# HISTORIC AND DESIGN REVIEW COMMISSION

February 07, 2024

**HDRC CASE NO:** 2024-039  
**ADDRESS:** 511 MISSION ST  
**LEGAL DESCRIPTION:** NCB 2879 BLK 4 LOT 5  
**ZONING:** RM-4, H  
**CITY COUNCIL DIST.:** 1  
**DISTRICT:** King William Historic District  
**APPLICANT:** PHILLIP DECKARD  
**OWNER:** PHILLIP DECKARD  
**TYPE OF WORK:** Balcony modification, column replacement, new construction of a rear accessory  
**APPLICATION RECEIVED:** January 02, 2024  
**60-DAY REVIEW:** March 2, 2024  
**CASE MANAGER:** Claudia Espinosa

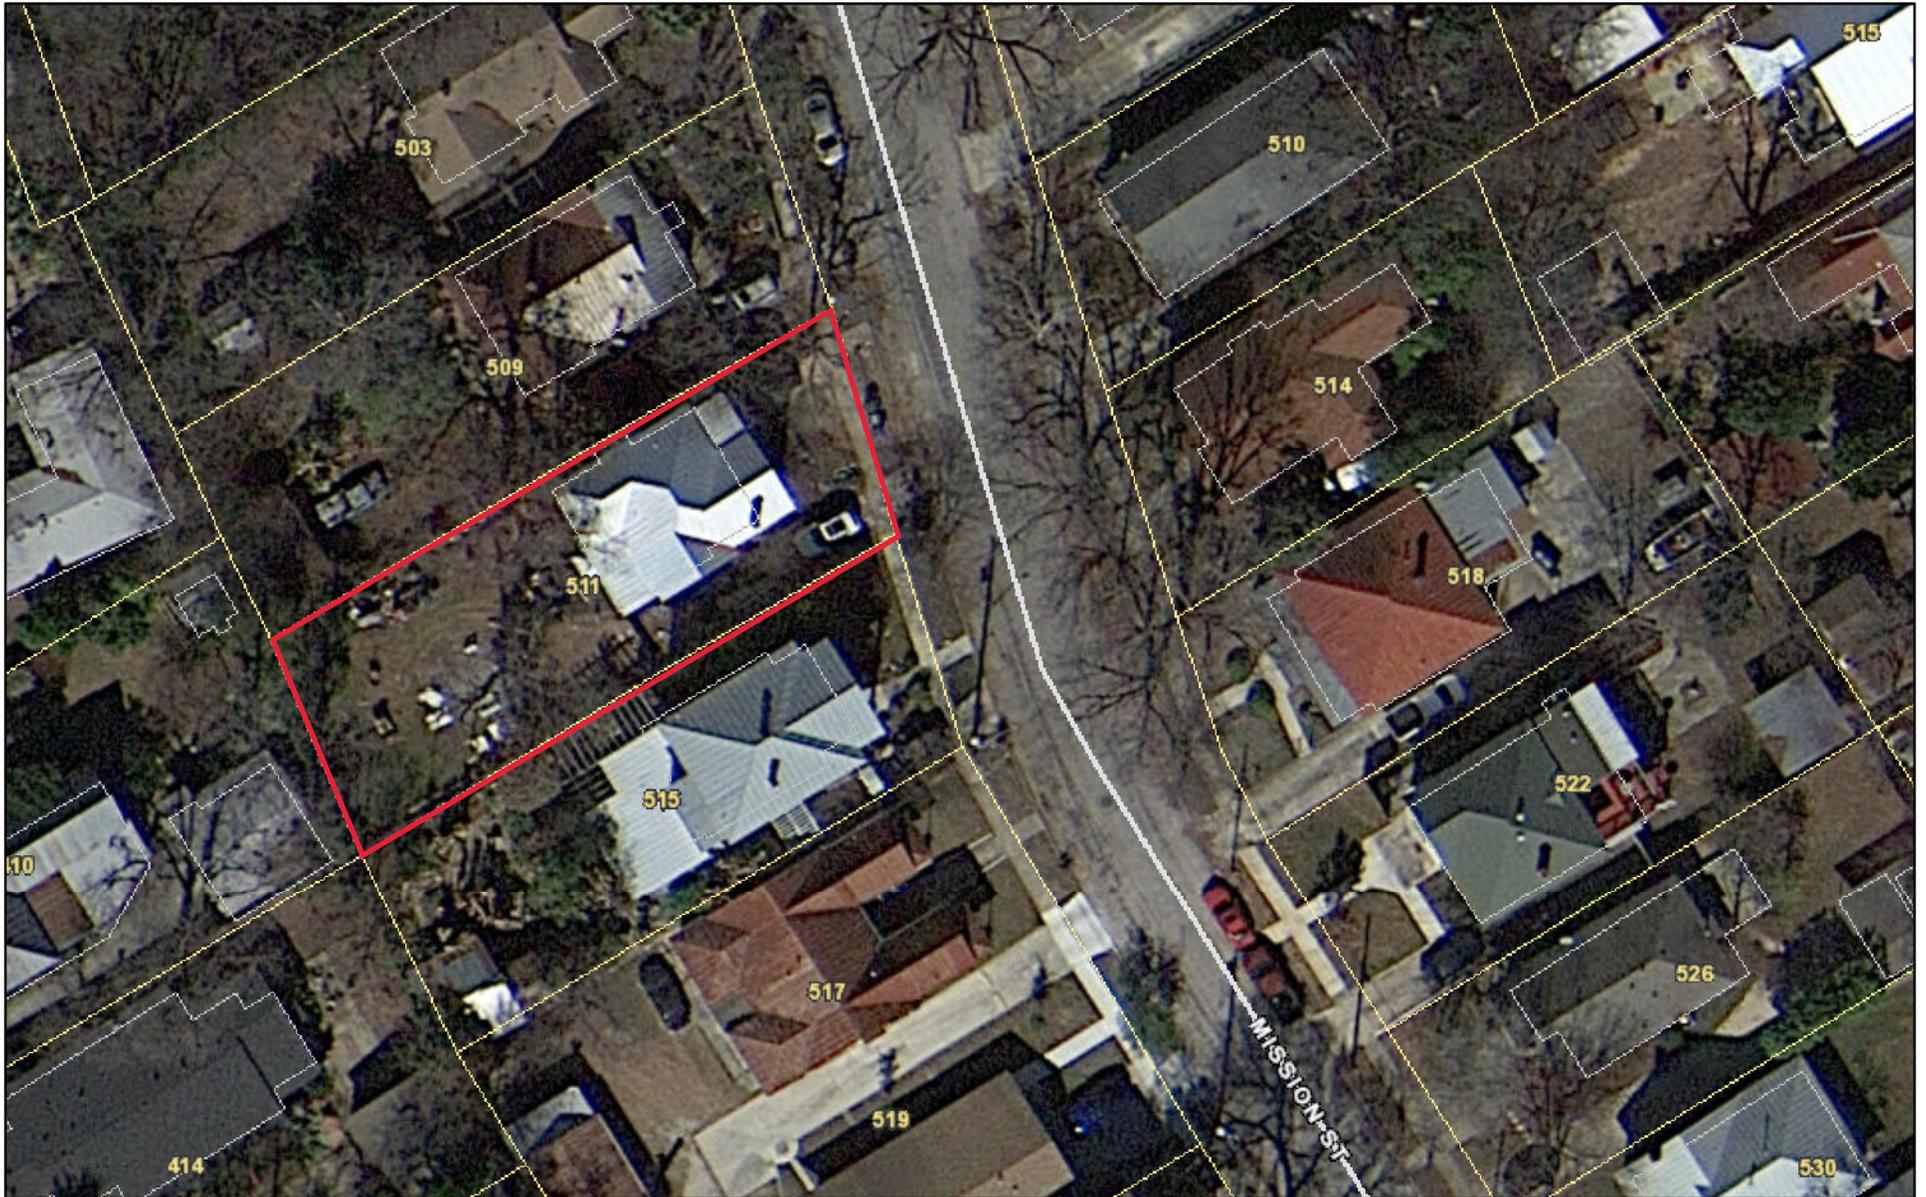
Item 2, staff does not recommend the porch column replacement based on finding c. The current porch columns are consistent with the architectural style of the house.

A5.1

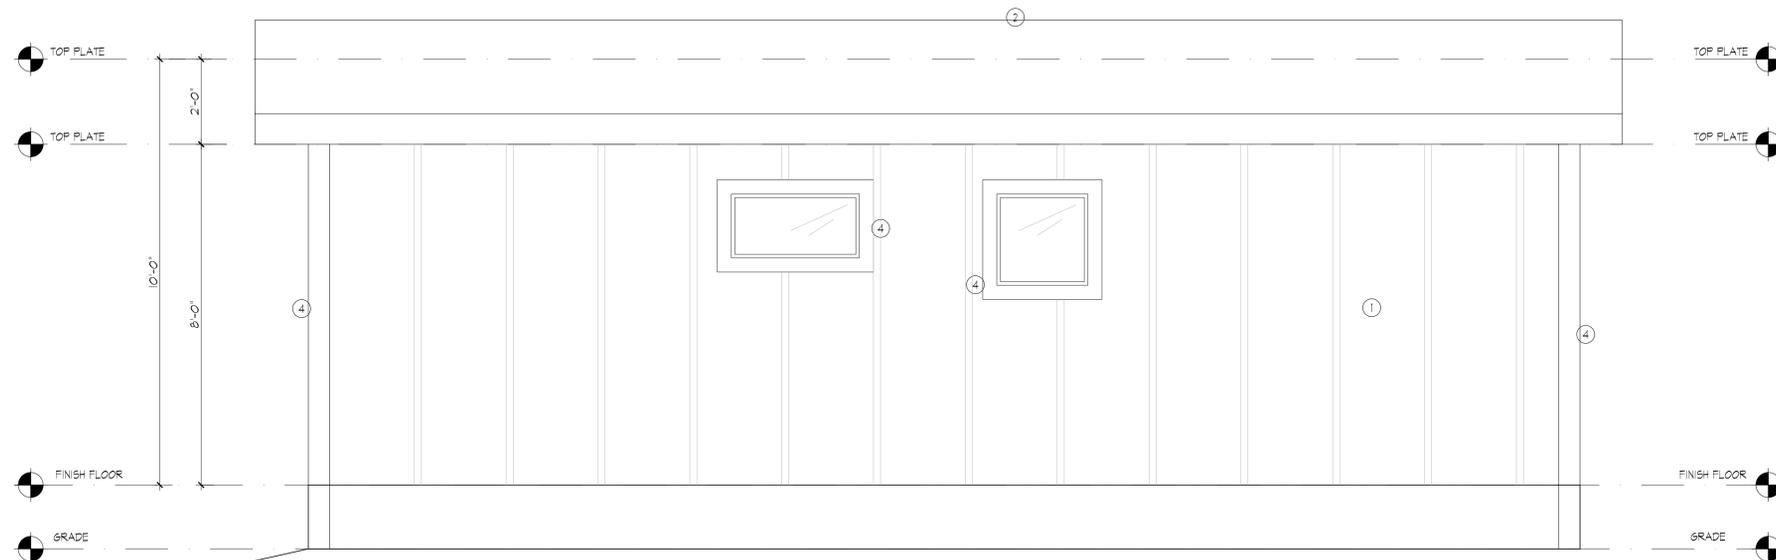
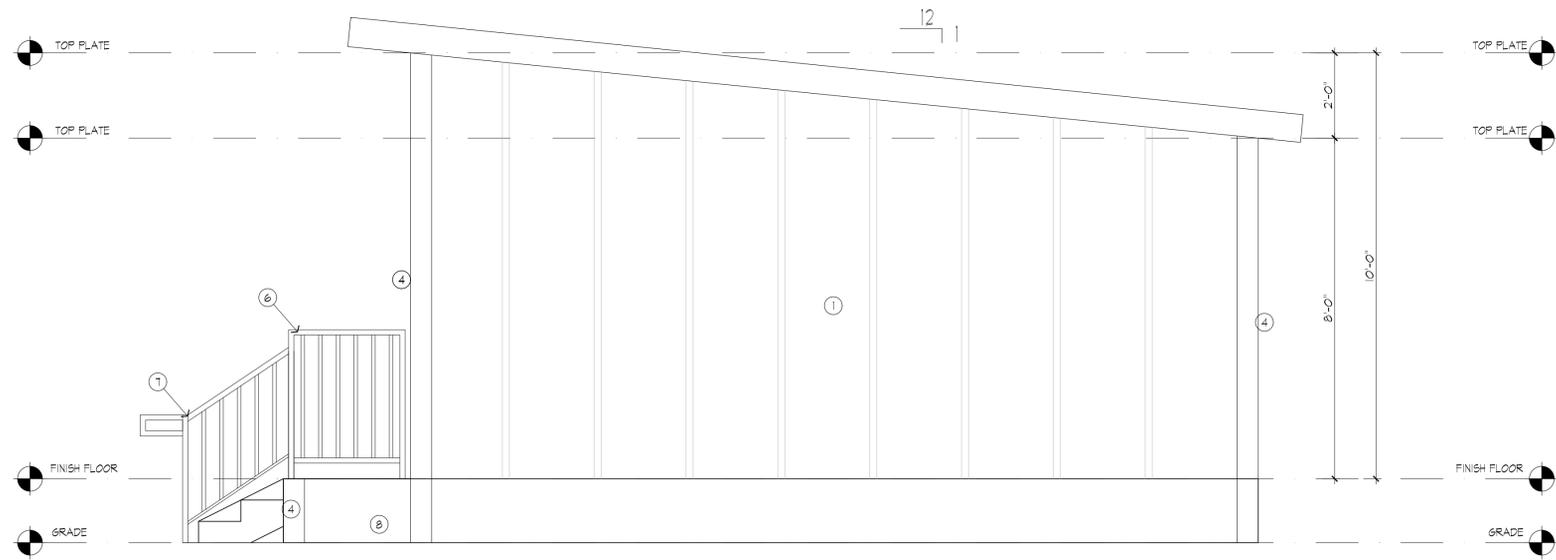
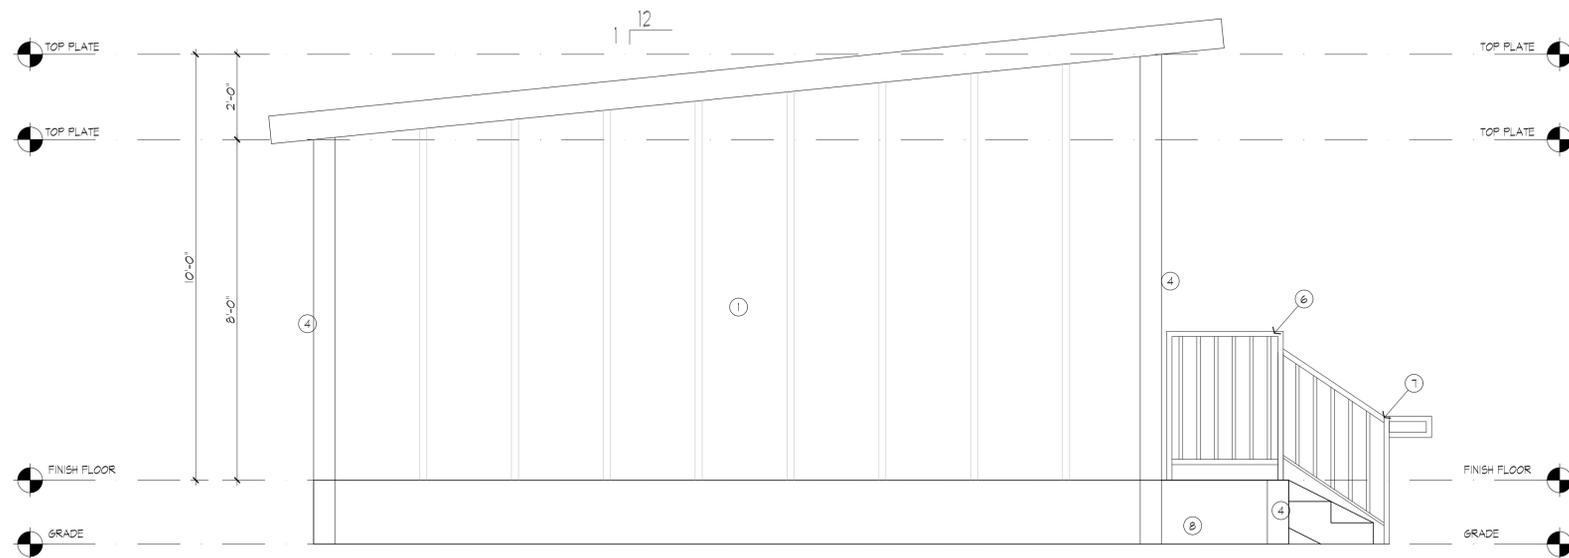
h. **REAR ACCESSORY: SOLIDS AND VOIDS** - The applicant has proposed to install aluminum-clad wood windows, on the north and south elevations. Guideline 2.C.ii for New Construction states to avoid blank walls, particularly on elevations visible from the street. No new façade should exceed 40 linear feet without being penetrated by windows, entryways, or other defined bays. Additionally, Guideline 2.C.i for New Construction states that new construction should incorporate window and door openings with a similar proportion of wall-to-window space as typical with nearby historic facades. Windows, doors, porches, entryways, dormers, bays, and pediments shall be considered similar if they are no larger than 25% in size and vary no more than 10% in height-to-width ratio from adjacent historic facades. The applicant has proposed to install four (4) one-over-one windows on the front façade, with a row of clerestory windows, and one set of French doors. The applicant has not proposed fenestration on the side elevations, which span only 14 feet in length. The applicant has proposed to install two (2) fixed windows of differing proportions on the rear elevation. Staff finds that the windows proposed for the rear elevation feature proportions that are not traditionally found on historic structures. Staff finds that the applicant should install windows on the rear elevation that feature traditional proportions and operations.

- i. That the applicant updates that fenestration pattern on the rear elevation to feature windows with traditional proportions and operations based on finding h. The applicant is required to submit updated elevation drawings to staff for review and approval prior to the issuance of a Certificate of Appropriateness.
